SERVICE BULLETIN

SEAM CLAMP BOLT

No. 240.2

REPLACING THE SEAM CLAMP BOLT AND NUT PMC-1002, PMC-1001, PMC-1300, PMC-1300NR

INSTRUCTIONS:

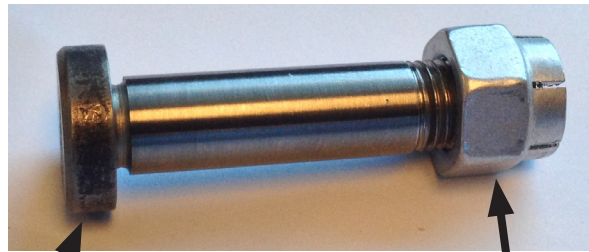
Paper Machinery Corporation is replacing the current seam clamp bolt and nut on the 1002, 1001, 1300, and 1300NR. Field reports have indicated that the current seam clamp bolt part #113-477 can break if over tightened. Replacement seam clamp bolt is part #7013952 and uses nut part #NT-11020. Please contact the service department for pricing and availability.

Torque nut to 15 ft/lbs.

**NEW BOLT
 PART #7013952**

**NEW NUT
 PART #NT-11020**
